File In Section: Product Recalls  
Bulletin No.: 09298B  
Date: January 2010

# Recall Bulletin

**SUBJECT:** Heating and Windshield Defrost Inoperative – Replace Computer Module

**MODELS:** 2010 Chevrolet Equinox  
2010 GMC Terrain

2383879

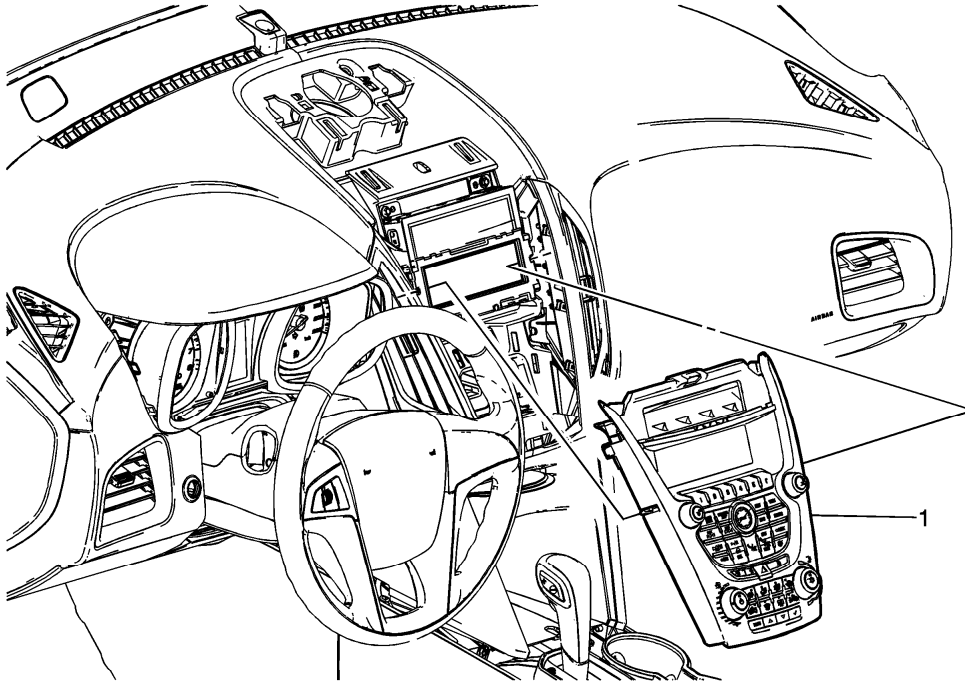
The Service Procedure in this bulletin has been revised to provide additional information on removing the center instrument panel to prevent damage to the panel. Please review the revised service procedure immediately.

**Caution:** Insert a plastic body trim tool between the IP and radio control assembly along the top portion of the radio control assembly as shown in the illustration. **DO NOT** use a flat-blade screw driver to remove the radio control assembly.
